**EAST SLOPE WATER  
COMPANY'S APPLICATION  
TO AMEND DECISION NO.  
73091**

## MEMORANDUM

**Date:** November 5, 2014 (Revised December 22, 2014)

**Project No.:** **EAST SLOPE WATER COMPANY WATER SYSTEM EVALUATION  
SUPPLEMENT  
WESTLAND PROJECT NO. 1820.01**

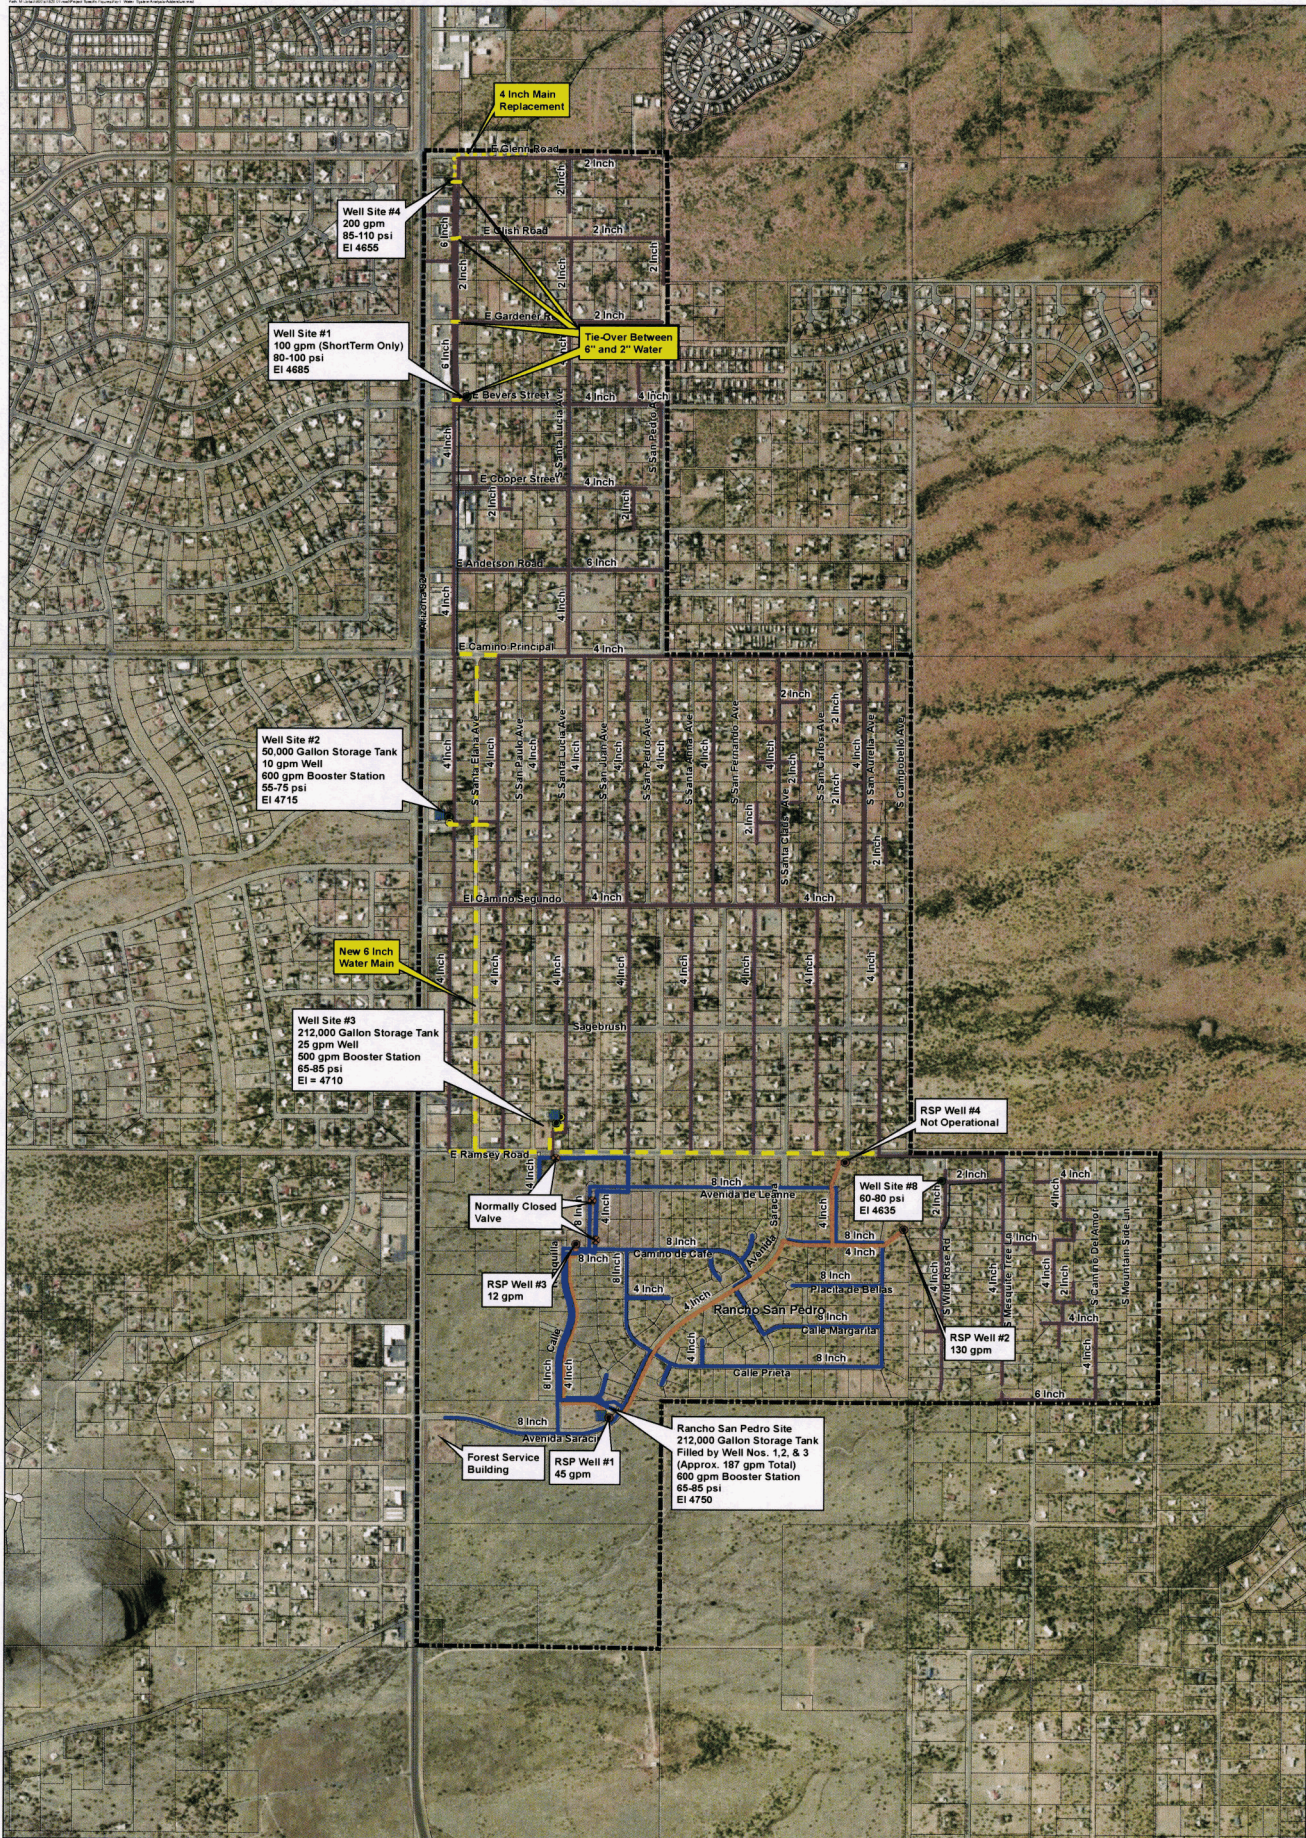
Based on the review of water system demands, infrastructure capacities, and hydraulic modeling, there are a number of recommendations for upgrades to the MWS, as discussed in the following sections. The recommendations discussed in this section are presented on **Figure 1**. Opinions of Probable Construction Cost (OPCCs) are provided in **Appendix A**. Costs include engineering, permitting, construction services, and contingencies.

The review of the existing water system and hydraulic modeling evaluation resulted in recommendations for water main projects within the MWS as shown on **Figure 1**. The existing water system has numerous sections of undersized water mains, which contribute to regular pressure problems in various portions of the water system, especially during peak demand periods. These issues occur regularly, and are especially problematic during well outages when water from one area of the system needs to be moved to other areas. In addition, these water mains do not meet current water system capacity standards, and often are not constructed of standard water system materials meeting current engineering and sanitary requirements. Pipeline looping, interconnection, and main replacement projects proposed for the MWS total approximately 12,700 linear feet of water main. These installations will take place in existing disturbed rights-of-way.

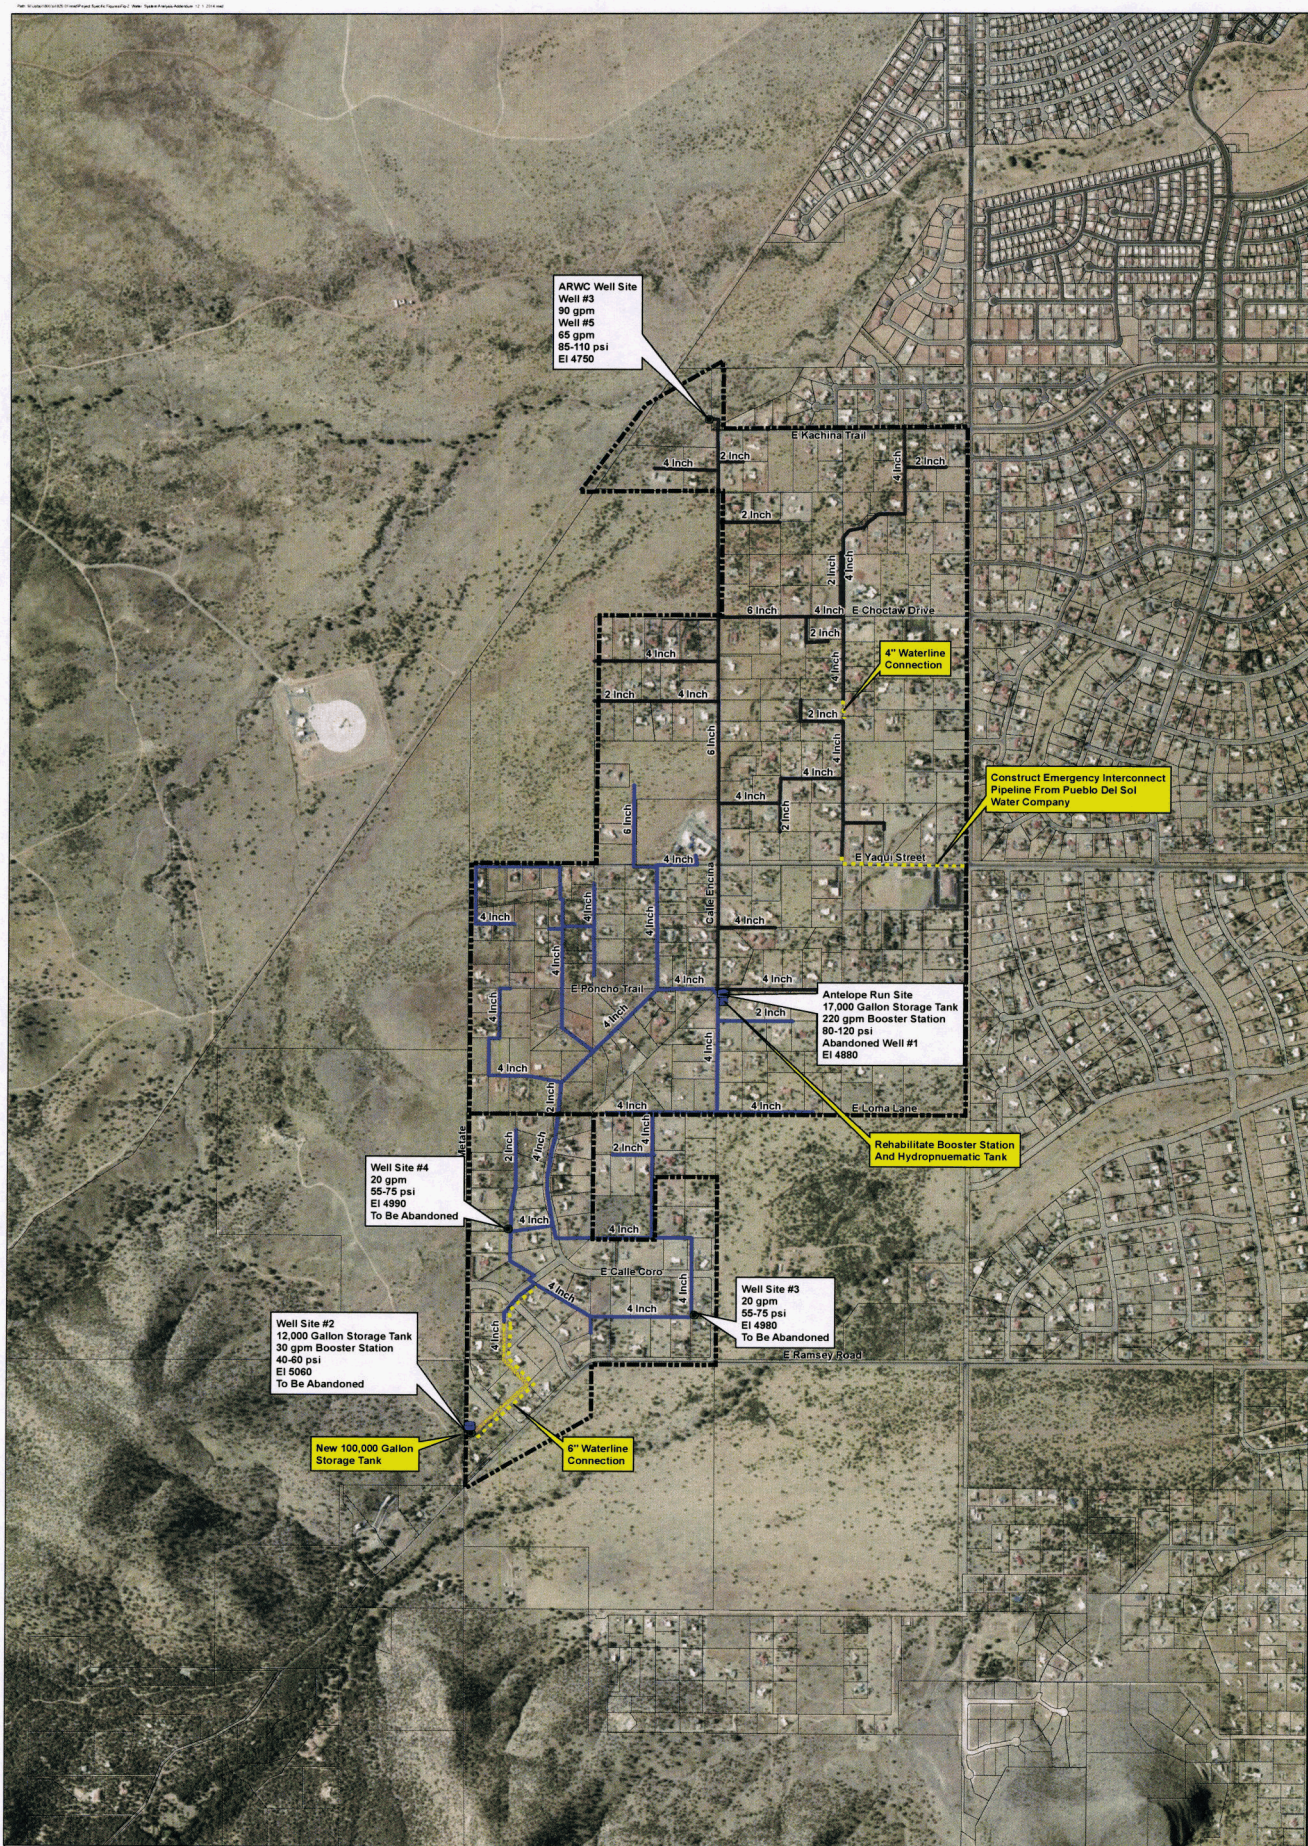
Based on the review of water system demands, infrastructure capacities, and hydraulic modeling, there are a number of recommendations for upgrades to the WWS, as discussed in the following sections. The recommendations discussed in this section are presented on **Figure 2**. Opinions of Probable Construction Cost (OPCCs) are provided in **Appendix A**. Costs include engineering, permitting, construction services, and contingencies.

The current storage capacity in the WWS is not sufficient to meet typical storage requirements or satisfy existing water system demands. A new storage tank is proposed at the existing Water Plant No. 2 site to improve water system storage capacity. The purpose of the project is to provide a location for storage of pumped water for purposes of meeting hourly peak demands, and to float the South Zone of the water system from the new tank. Due to property constraints, the existing 12,000 gallon storage tank at that site will be replaced with a tank of approximately 100,000 gallon capacity. The final tank size is dependent on the actual tank configuration that can fit and be permitted on the existing site.

The current booster station capacity in the WWS is not sufficient to adequately transfer water, meet peaking demands, and provide redundancy. The existing Antelope Run Booster Station and hydropneumatic tank will be upgraded to provide capacity sufficient for serving the demands of the South Zone with proper redundancy. This installation will take place at an existing disturbed site.

Similar to the MWS, the WWS contains mostly small diameter existing pipelines and lacks proper looping. The review of the existing water system and hydraulic modeling evaluation resulted in recommendations for water main projects within the WWS as shown on *Figure 2*. One section of approximately 300 linear feet of 4-inch water main is proposed in the West System, to loop together two dead end mains for purposes of improving flow transfer capabilities and pressures within the West System. As previously described, the pipeline interconnection to PDS Water Company, and storage tank replacement projects also include pipeline installations. These installations will take place in existing disturbed rights-of-way.
